NP-11-0028  
June 30, 2011

Subject: Exelon Nuclear Texas Holdings, LLC  
Victoria County Station Early Site Permit Application  
Response to Request for Additional Information Letter No. 07  
NRC Docket No. 52-042

Attached are responses to NRC staff questions included in Request for Additional Information (RAI) Letter No. 07, dated April 8, 2011, related to Early Site Permit Application (ESPA), Part 2, Sections 02.04.06, 02.05.02, and 11.02. NRC RAI Letter No. 07 contained twenty Questions. This submittal comprises a partial response to RAI Letter No. 07, and includes responses to the following two (2) Questions:

Figure 1.

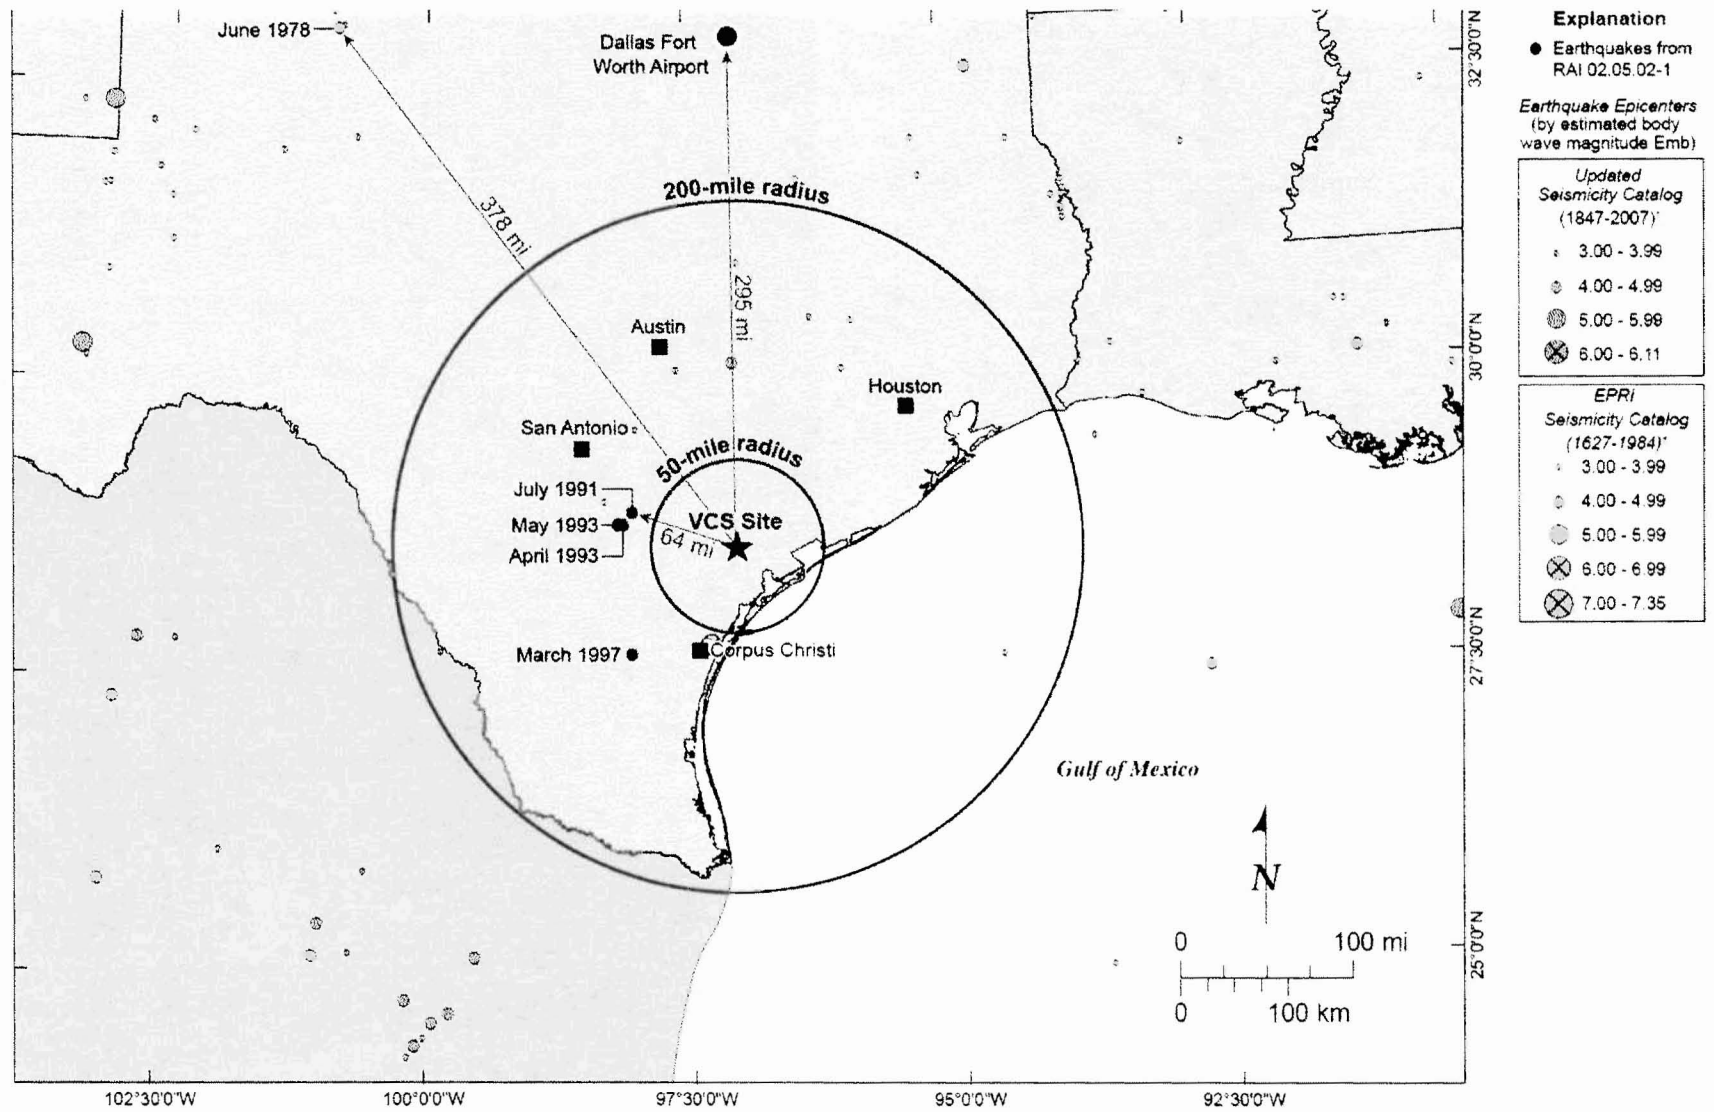
SSAR Figure 2.5.1-51 shows locations of oil and gas wells in southern Victoria County. Oil and gas exploration and extraction are capable of inducing seismic events. In SSAR Section 2.5.2, the applicant did not discuss human-induced seismicity resulting from gas and oil extraction. Please discuss the history of any induced seismicity from oil and gas extraction in the region and the future potential for increased seismic hazard at the VCS site.

Fluid injection is thought to trigger seismicity by reducing the effective stress across faults (through increasing the pore pressures) and thus weakening the faults (Frohlich and Davis, 2002; Majer et al., 2007). The largest earthquake associated with fluid injection reported in Texas is the 16 June 1978 mb 4.3 to 4.6 earthquake near Snyder, over 350 miles to the northwest of the VCS site (Figure 1) (Davis and Pennington, 1989; Frohlich and Davis, 2002). This event was part of a series of earthquakes associated with fluid injection within the Cogdell oil field. Beginning in later 2008, a series of small earthquakes with  $mb \leq 3.3$  have occurred near the Dallas-Fort Worth airport, over 290

miles from the VCS site (Figure 1). Despite the small magnitudes of these earthquakes, they have received extensive media coverage due to their association with waste water injection (Frohlich et al., 2011; Frohlich et al., 2010).

SSAR Figure 2.5.2-2 shows the seismicity surrounding the site as well as the 200-mile (site region) and 50-mile buffers around the site. As shown in SSAR Figure 2.5.2-2, there is no seismicity within 50 miles of the site and relatively little seismicity within 200 miles of the site. The seismicity shown in this figure comprises earthquake epicenters in both the original EPRI-SOG seismicity catalog and the updated seismicity catalog developed for the VCS site (see SSAR Section 2.5.2.1). As described in SSAR section 2.5.2.1 and in the response to RAI 02.05.02-1, the updated catalog includes tectonic earthquakes and has had all likely man-made earthquakes removed. The response to RAI 02.05.02-1 briefly discusses four man-made earthquakes that have been removed from the updated catalog. Three of these events (July 1991, April 1993, May 1993) are the closest reported man-made earthquakes to the VCS site with  $Emb \geq 3.0$ . The closest approach of these earthquakes to the site is approximately 60 miles (Figure 1). Therefore, there are no reported man-made earthquakes, including any earthquakes triggered by oil and gas production-related activities (e.g., extraction, injection, hydraulic fracturing) within 50 miles of the site. Given the absence of earthquakes associated with oil and gas production within 50 miles of the site, despite the presence of oil and gas wells surrounding the site (SSAR Figure 2.5.1-52), and the small magnitudes of earthquakes related to oil and gas production within Texas, earthquakes associated with oil and gas production are not likely to increase the seismic hazard for the VCS site.
